Nature of visit: Review odour controls.

Issues raised requiring written response:

Photo 1 – SA1

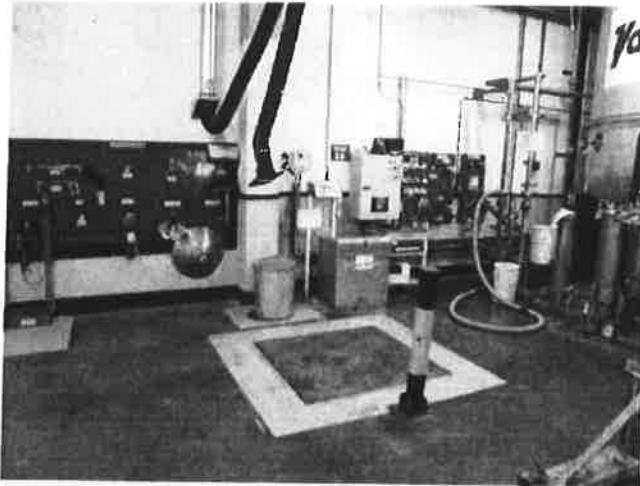
2. SA1 LEV discharge to air point

SA1 LEV was commissioned on the 28/11/2014 and is used to control exposure levels within the SA1 operating area and BP11 operating area within coatings. Refer to Photo 1 & Photo 2:

Site Plan 1:

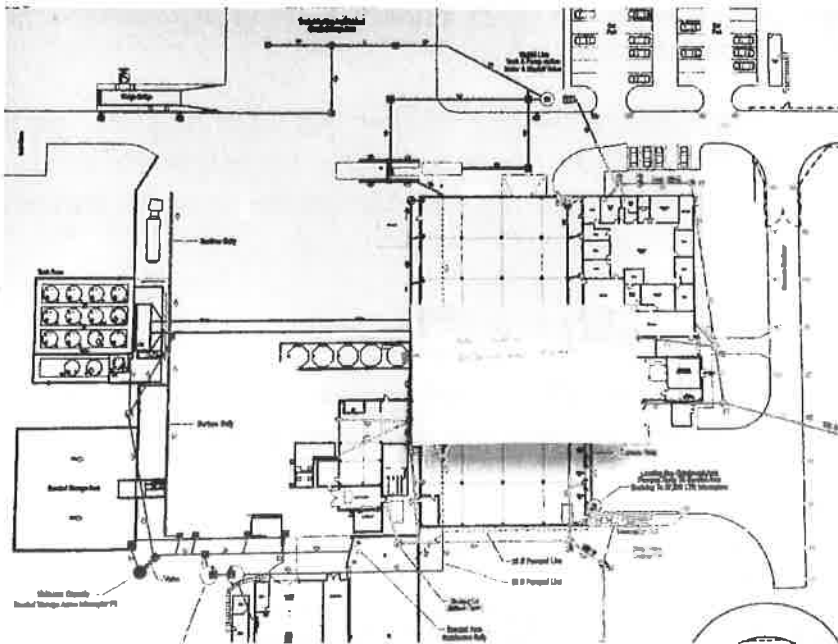
The SA1 external discharge point is shown on Site Plan 1 and Photo 3 & 4:

Photo 5:

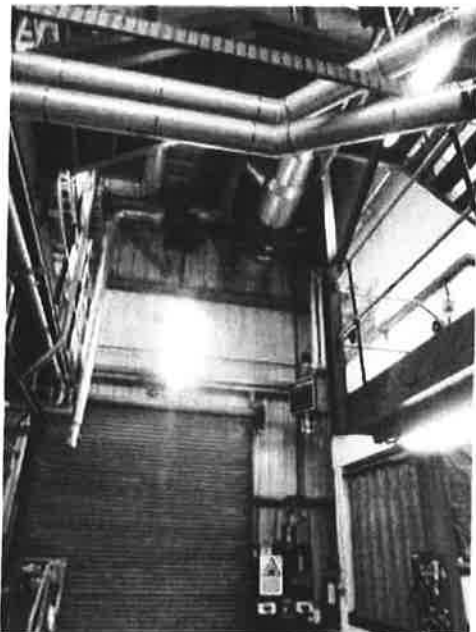
3. Resin TK Filters LEV discharge to air point

The Resin LEV unit was commissioned on the 28/11/2014 and is used to control exposure levels within the Resin TK Filters operating area. Refer to Photo 5:

Site Plan 2:

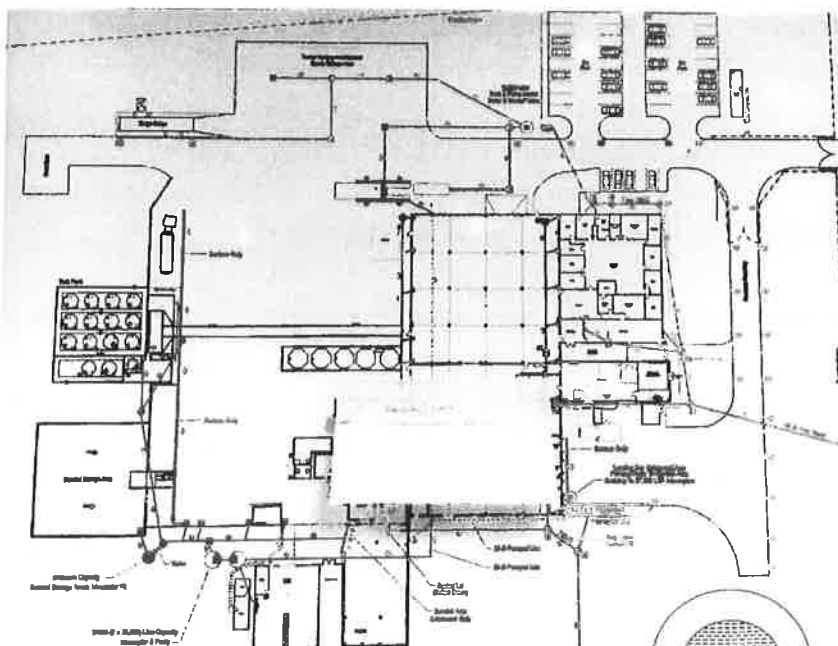
Resin external discharge point is shown on Site Plan 2 and Photo 6:
